TROY HS 0311(1)
 DRAINAGE SHEET # 18

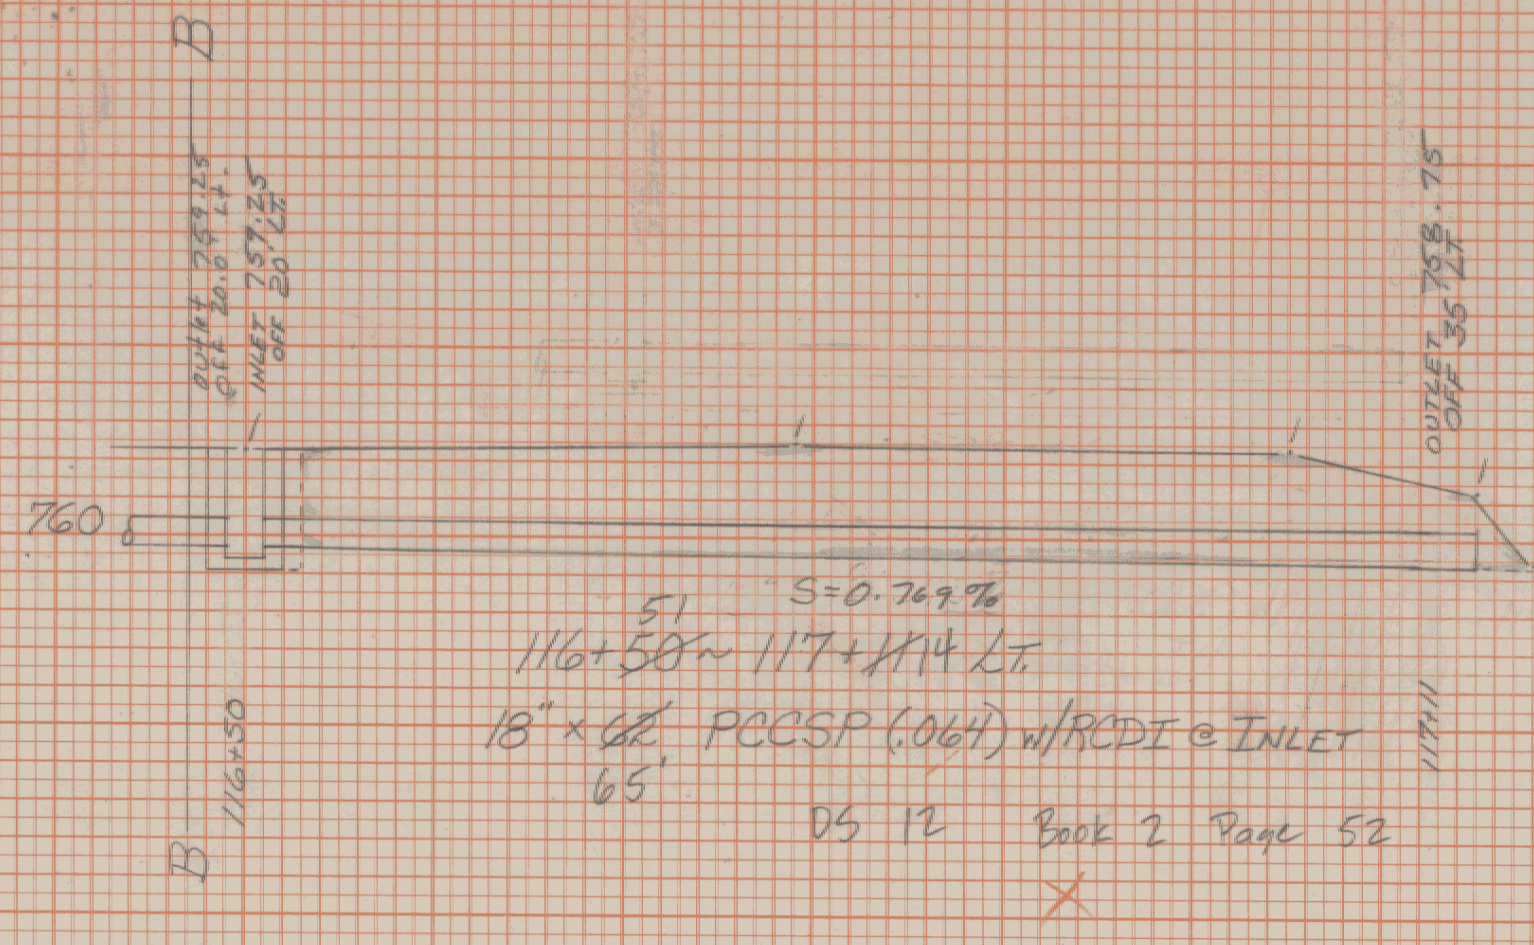
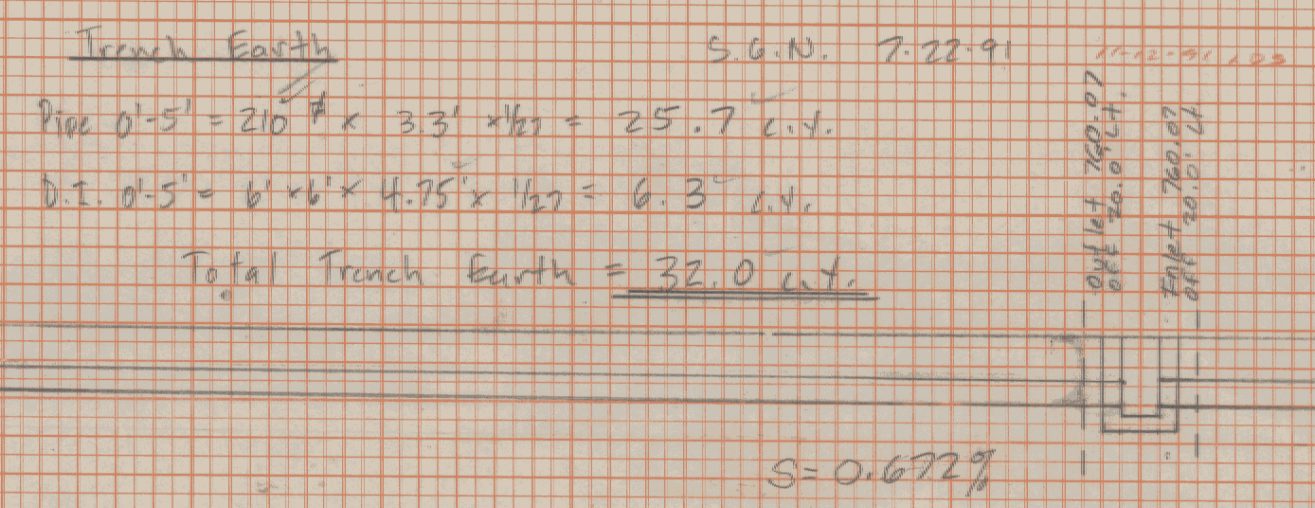
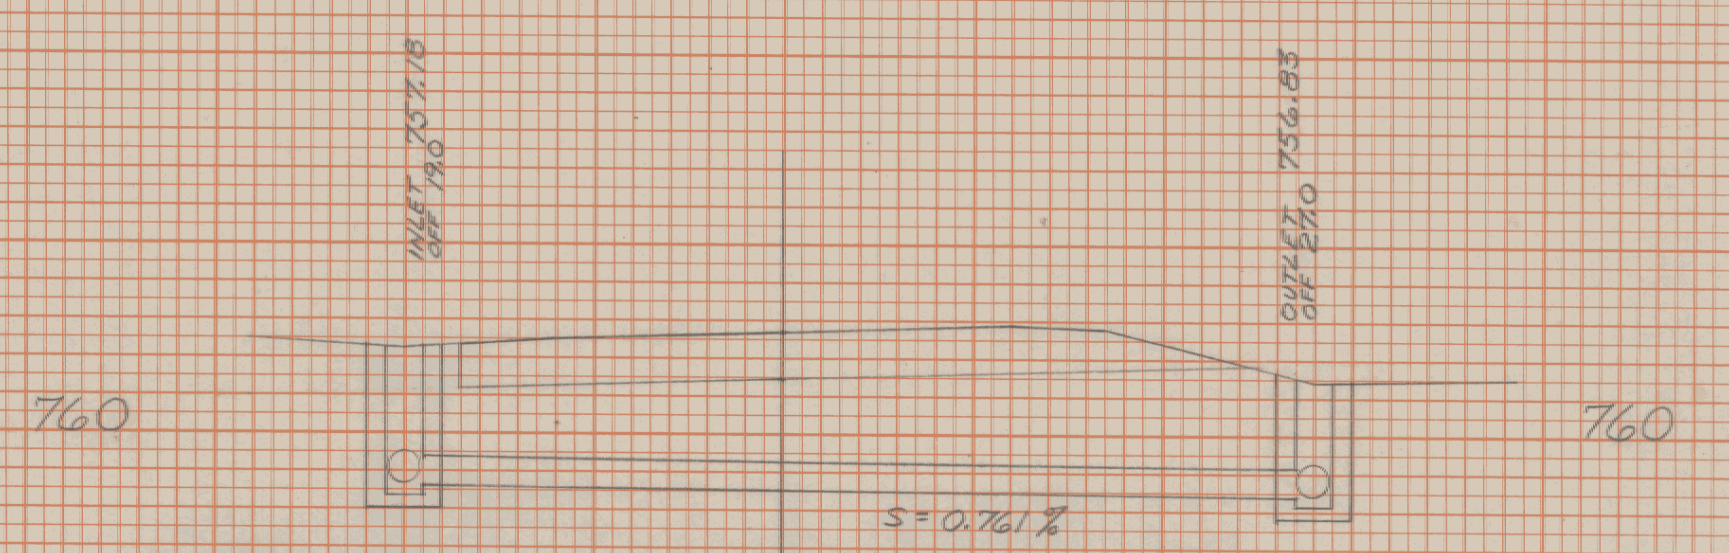
TRENCH EARTH
 PIPE 25.5 FT x 3.6 = 27 = 47.3 c.y.
 D.I. 6' x 6' x 5' = 27 = 37 c.y.
 D.I. 6' x 6' x 1.5' x 1.5' x 1.5' = 3.0 c.y.
 TOTAL TRENCH EARTH = 87.3 c.y.
 S.G.N. 7-22-91

Trench Earth
 Pipe 0'-5' = 527 ft x 3.3' x 1/2 = 76.7 c.y.
 D.I. 0'-5' = 6' x 6' x 5' x 1/2 = 6.7 c.y.
 Total Trench Earth = 83.4 c.y.
 S.G.N. 7-22-91

116+50 Lt-Rt
 18" x 16" RCP Cl. III w/RCDI @ INLET
 Book 2, Page 50 (DS 12)
 VOID 5/15/91
 Pipe Eliminated

114+50 ~ 115+14 Lt.
 18" x 16" RCP Cl. III w/RCDI @ INLET
 CONNECT CELLAR DRAIN TO D.I.
 Book 2, Page 30 (DS 07)

Trench Earth
 Pipe 0'-5' = 292 ft x 3.3' x 1/2 = 35.7 c.y.
 D.I. 0'-5' = 6' x 6' x 4.5' x 1/2 = 6.0 c.y.
 Total Trench Earth = 41.7 c.y.

Pipe Eliminated
 111+91 ~ 112+50 Lt.
 18" x 58" RCP Cl. III w/RCDI @ INLET
 Book 2F, Page 134 (DS 301)
 ASSISTED
 REDESIGNED
 VOID 5/15/91

Pipe Eliminated
 112+50 ~ 113+58 Lt.
 18" x 106" RCP Cl. III w/RCDI @ INLET
 Book 2, Page 6 (DS 01)
 VOID 5/15/91

113+58 ~ 114+53 Lt.
 18" x 94" RCP Cl. III w/RCDI @ INLET
 Book 2, Page 18 (DS 01)
 Connect Cellar Drain to D.I.
